Application for Amendment of Plan Under Section 12A of the Town Planning Ordinance (Cap. 131) to Rezone the Application Site from “Green Belt” and Area shown as ‘Road’ to “Residential (Group C)5” for Proposed Residential Development at Various Lots in D.D. 210 and Adjoining Government Land, Pak Wai, Sai Kung (Planning Application No. Y/SK-HC/8)

Submission of Further Information – Responses to Departmental Comments

Responses-to-Comments Table

FIGURE 5

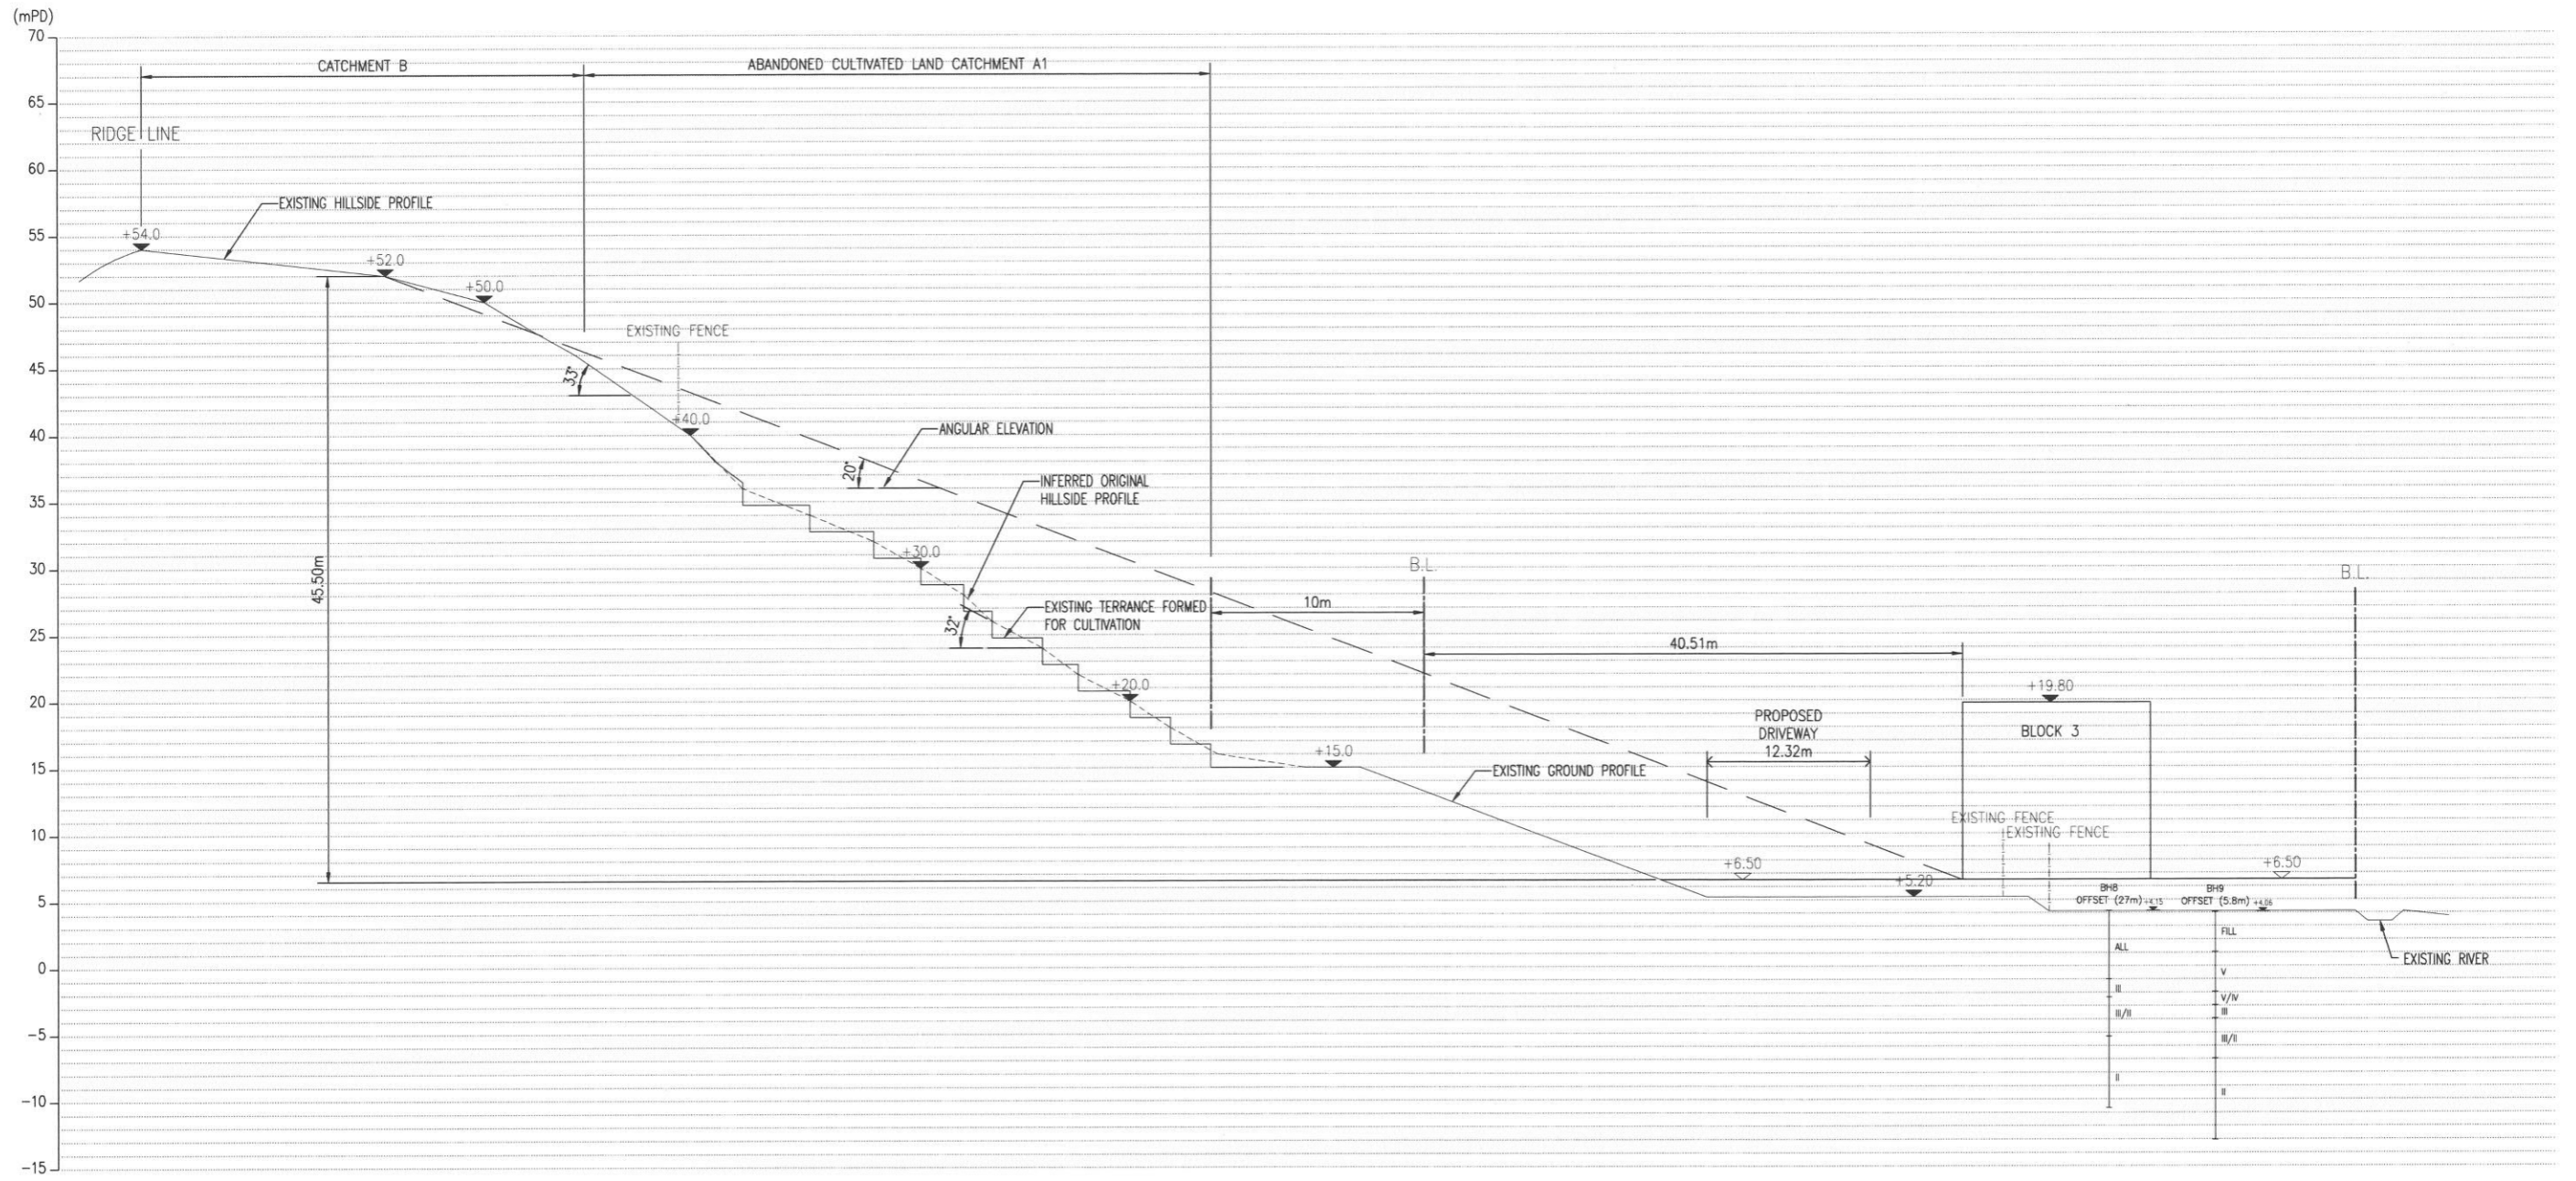
No.	Comments	Responses
1.	<p>Civil Engineering and Development Department, Geotechnical Engineering Office, Planning and Development Division, Engineering Geology Section, dated 10 October 2025</p> <p><u>Comments on the Geotechnical Planning Review Report (GPRR)</u></p> <p>1. Section 6.3: A screening in respect of natural terrain hazards related to the developments, shall be carried out in accordance with GEO Report No. 138, as part of the GPRR. The extent of natural terrains affecting the site that will be studied shall also be demarcated on a plan and included in GPRR.</p> <p><u>Reminders to the applicant</u></p> <p>2. It is noted that Feature Nos. 7SE-D/C154 and 7SE-D/F46 are located within and in the vicinity of the site. Please remind the applicant(s) to make necessary submissions to the District Land Office and/or the Building Authority for approval if the geotechnical feature(s) could affect or be affected by the proposed development (if any) in accordance with the provisions of the Buildings Ordinance at the development stage.</p>	<p>Noted. The screening in respect of natural terrain hazards related to the developments is provided in Sections 6.3.1 to 6.3.5 in the Revised Geotechnical Planning Review Report (Appendix B refers). The extent of natural terrain to be studied is demarcated in Figure 8 of the Report.</p> <p>Noted.</p>

Thus, referring to 2.3.4 Alert Criteria Fig 2.5, the only critical Cross Section A-A (Figure 5) fall within the requirement of a Natural Terrain Hazard Studies (NTHS) to be carried out. Since Catchment B have no landslide records since 1963 and the natural catchment is fully covered by mature vegetation. It is proposed the hillside in Catchment A1 disturbed by human activities shall carry out further study. The extent of natural terrains affecting the Site to be studied is demarcated in Figure 8.

DRAWING No.
 FIGURE D3

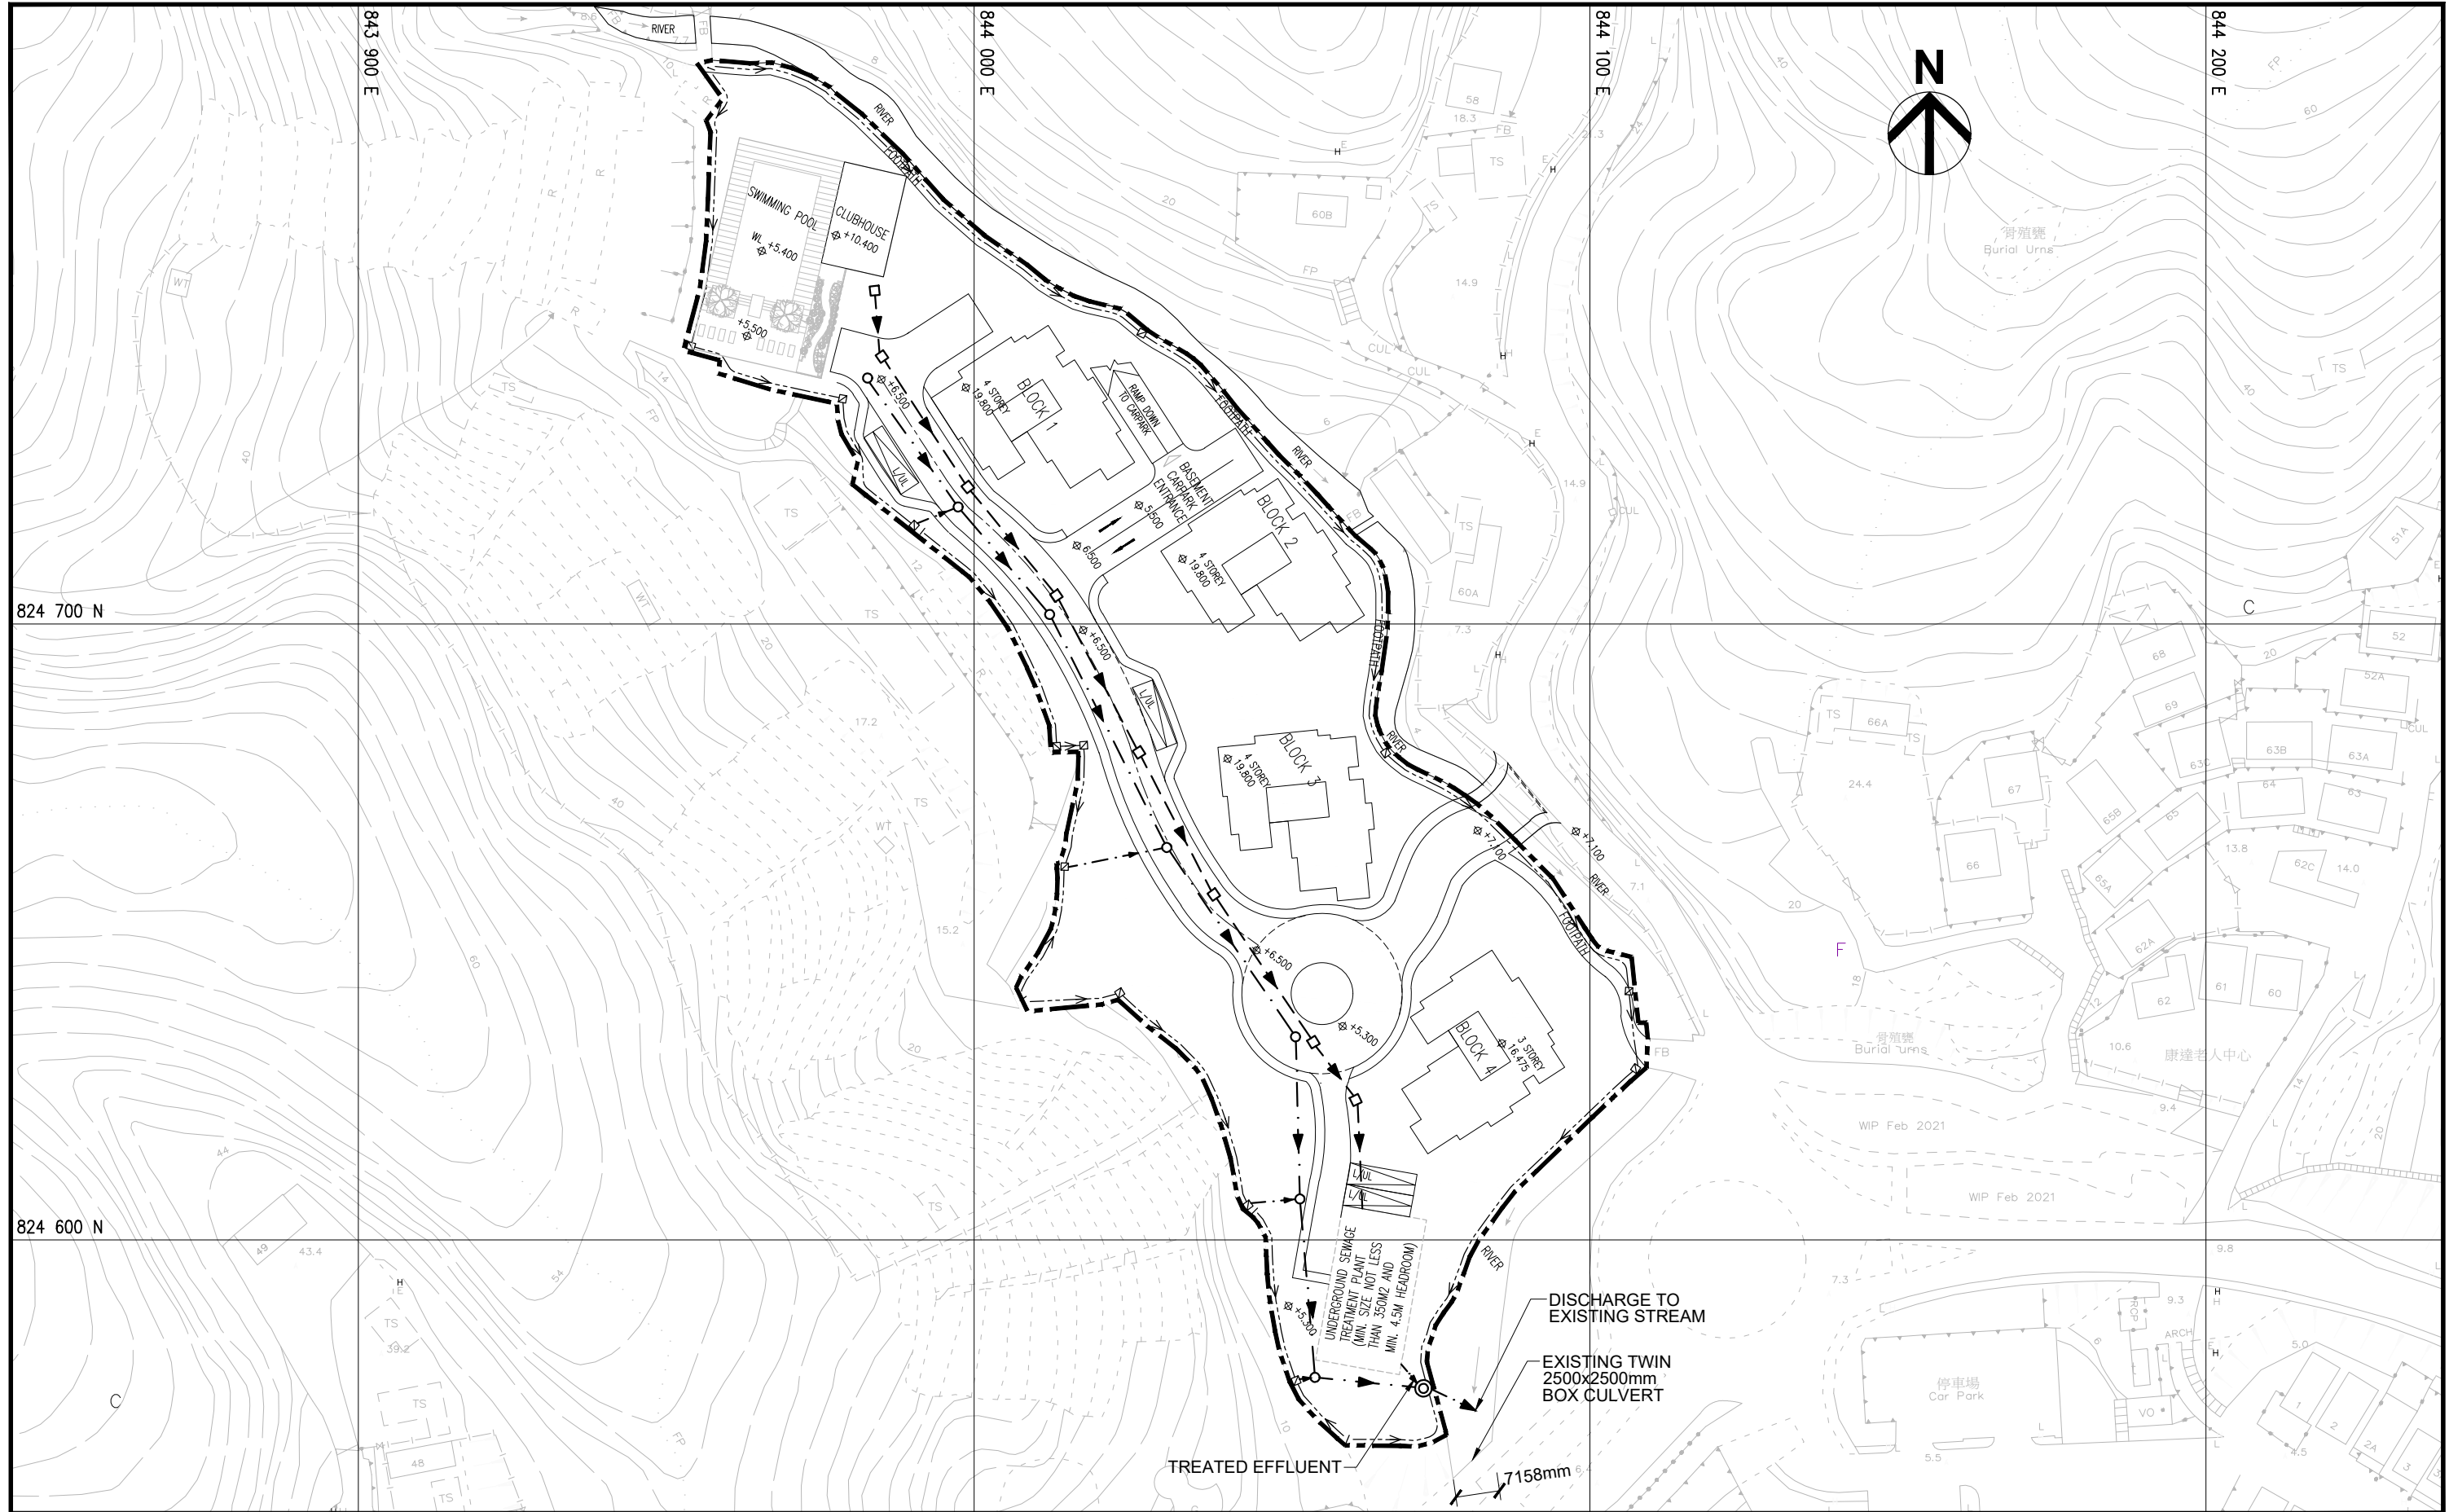
No.	Comments	Responses
	<p>2. Section 4.3 - Please verify whether the shape of existing watercourse match with your design assumption. Please request the applicant to select few critical sections to conduct assessment of capacity of the watercourse. Also, please present in elevation to prove there is sufficient freeboard of the river along your site.</p> <p>3. Section 4.3 - It is observed the topography of the site will be altered due to your development and it may affect the drainage path adjacent to the site(s). Please evaluate whether there is any impact to the adjacent site(s) due to your development.</p> <p>4. Section 4.3 - It is noted that a sewerage treatment plant is proposed within the site and the treated water will be discharged to existing box culvert. Please take it into account in the hydraulic calculation.</p> <p><u>Sewerage Impact Assessment</u></p> <p>5. The subject planning application needs to meet the full satisfaction of Environmental Protection Department (EPD), the planning authority of sewerage infrastructure. DSD's comments on the application are subject to views and agreement of EPD.</p>	<p>Please note that the selected critical section of the existing watercourse is the narrowest section at the discharge point of the subject site and in front of the inlet of an existing twin 2500x2500mm box culvert (refer to Figure D4 and Plates 4, 5 and 6 under Section 3.4 of the Revised DIA). It is considered conservative to adopt a 5m (wide) x 2m (deep) section, i.e. smaller than the total cross-sectional area of the existing twin box culvert, in assessing capacity of the concerned watercourse. Since the existing box culvert is 2500mm deep, the adopted narrowest section of the existing watercourse is 2000mm deep and the section is capable to convey the design peak flow, the freeboard of the existing watercourse would be not less than 2500mm – 2000mm = 500mm (the proposed ground level of the subject site is higher than the top of the existing box culvert).</p> <p>There would not be material change in the drainage paths of the concerned area. Peripheral channel is proposed to collect overland flow running across the subject site boundary and to convey the collected flow to the terminal manhole for discharge.</p> <p>Noted. Peak dry weather flow of 0.051111 m³/s of the proposed sewage treatment plant (adopted in the Revised Sewage Treatment and Disposal Proposal Report under the Application) has been added into the hydraulic calculation under Section 4.3 of the Revised DIA.</p> <p>Noted.</p>

Catchment area of the narrowest section of the existing watercourse (including the subject site area) (refer to **Figure D3**) = $(12,692 + 43,736 + 854,721)\text{m}^2 = 911,149\text{m}^2$
